Southern California Edison Company

Subject: Docket No. 50-363
San Onofre Nuclear Generating Station
Unit 3

SAN ONOFRE UNIT 3 TECHNICAL SPECIFICATIONS

FIGURE 3.4-2

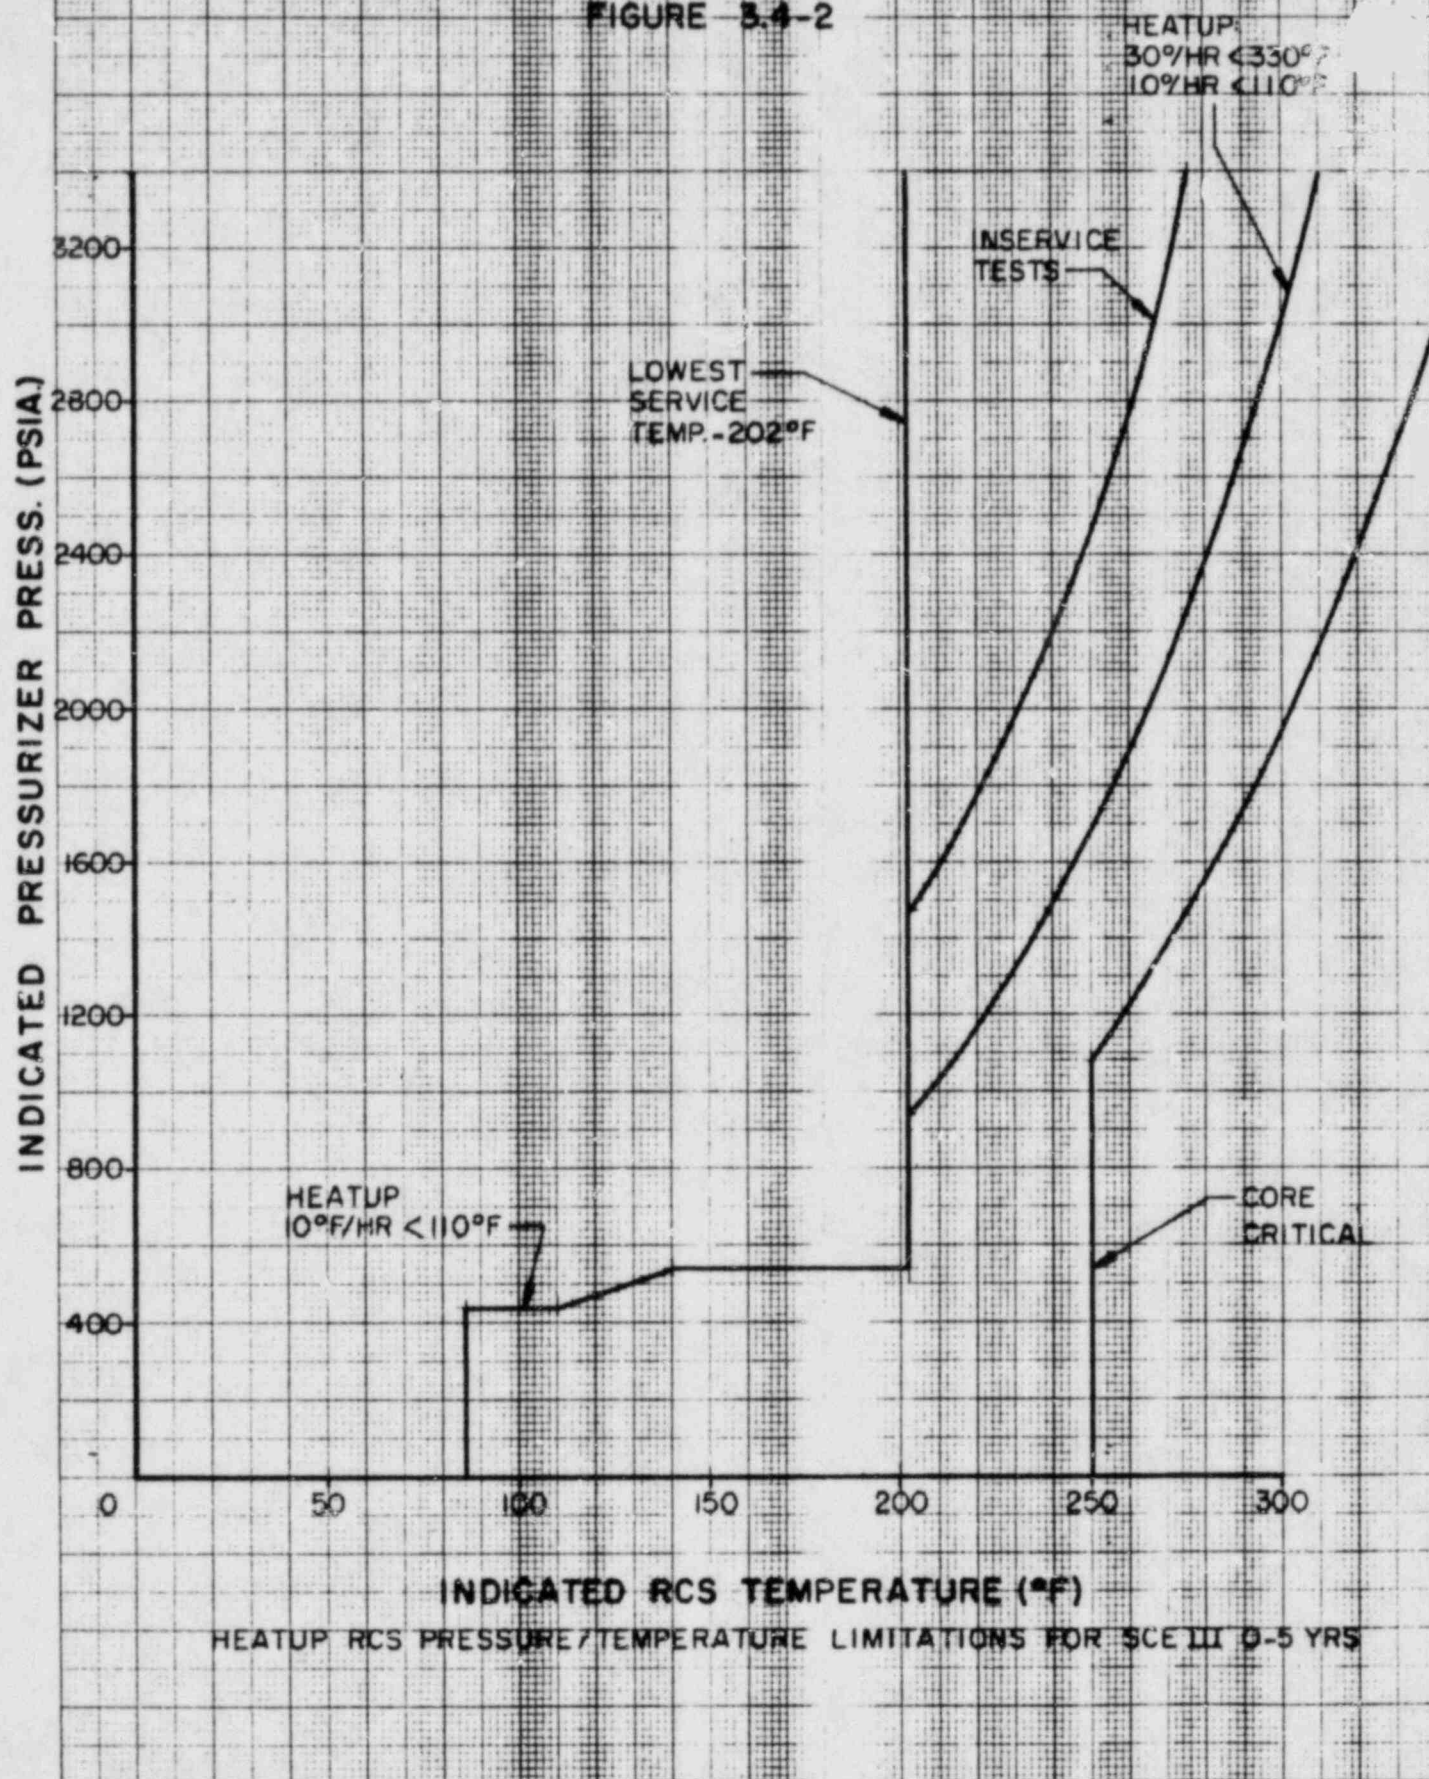
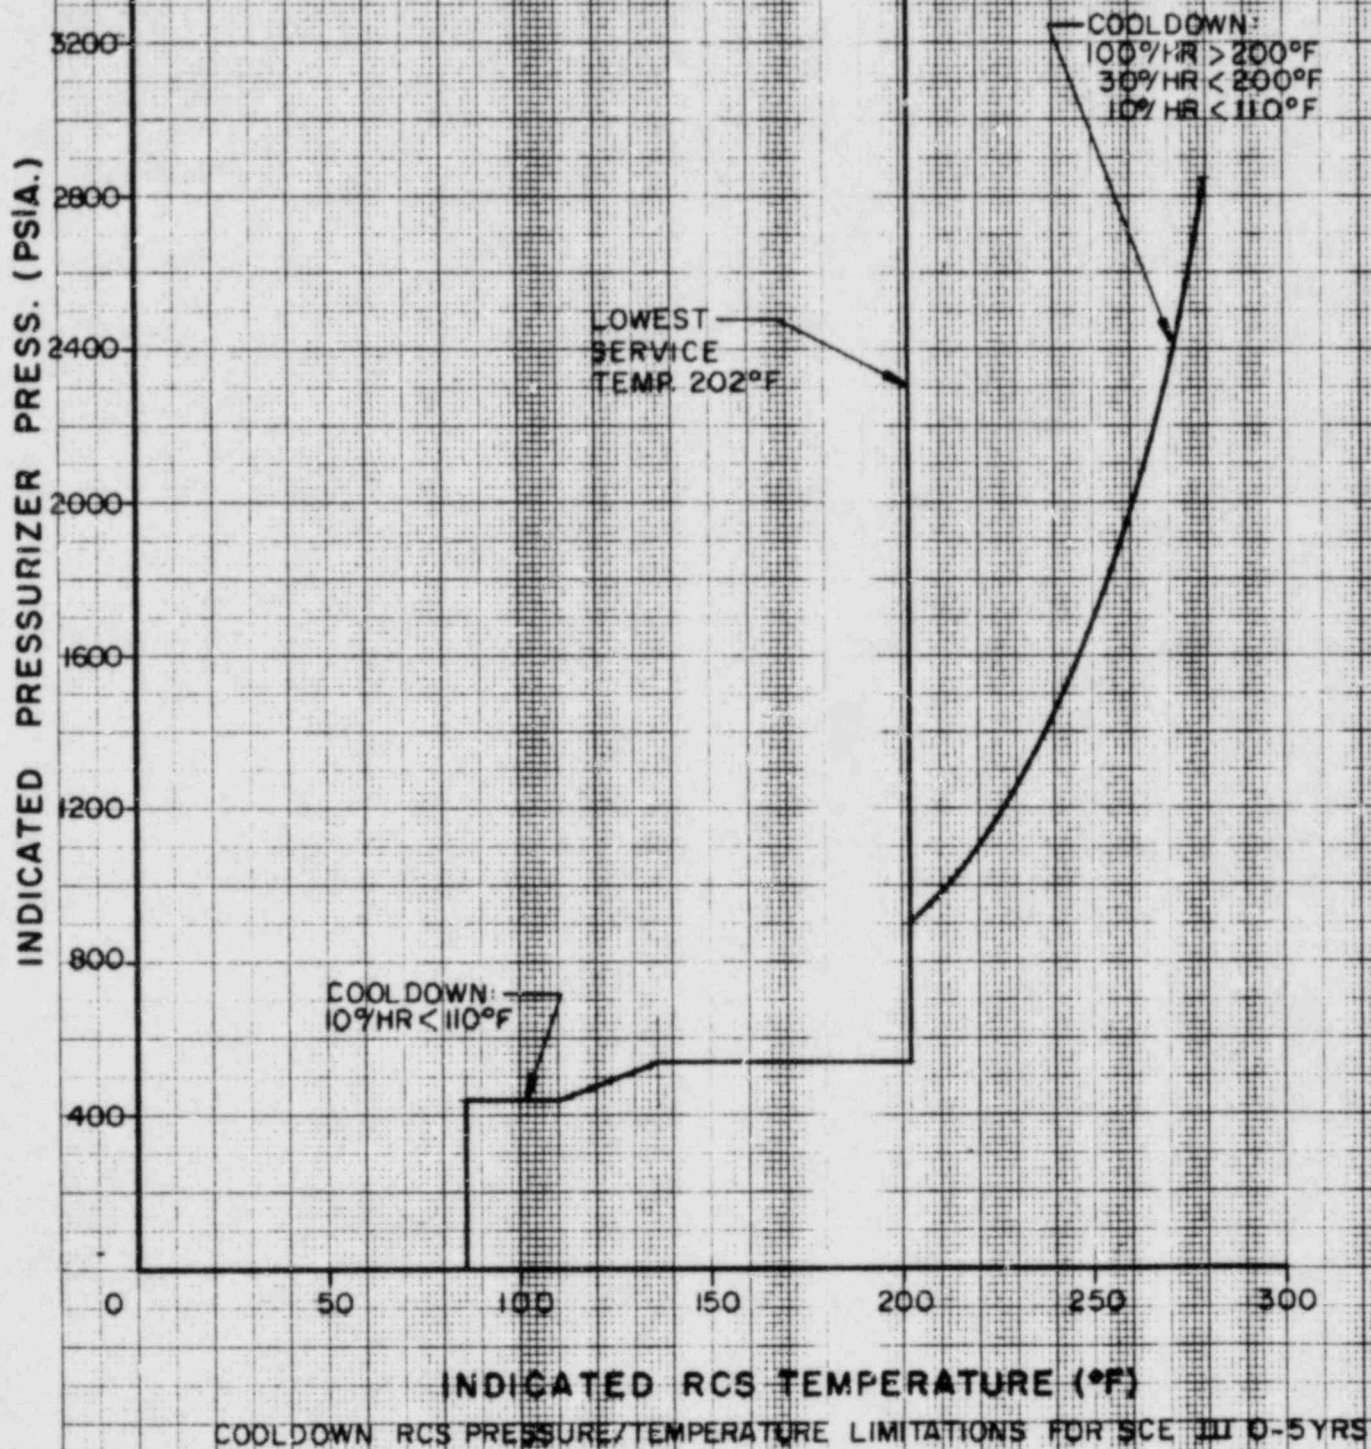
- Item 4 Provide heat up and cool down curves (Figures 3.4-2 and 3.4-3) applicable to Unit 3.

Figures 3.4-2 and 3.4-3 have been revised for Unit 3 and are included in Attachment 4. Additionally, corresponding changes to pages 3/4 4-3, 4-27, 4-32, 4-33, to Bases pages B 3/4 4-1, 4-6, 4-7, 4-9, and to Bases Table B 3/4, 4-1 are included in Attachment 4 reflecting differences from Unit 2.
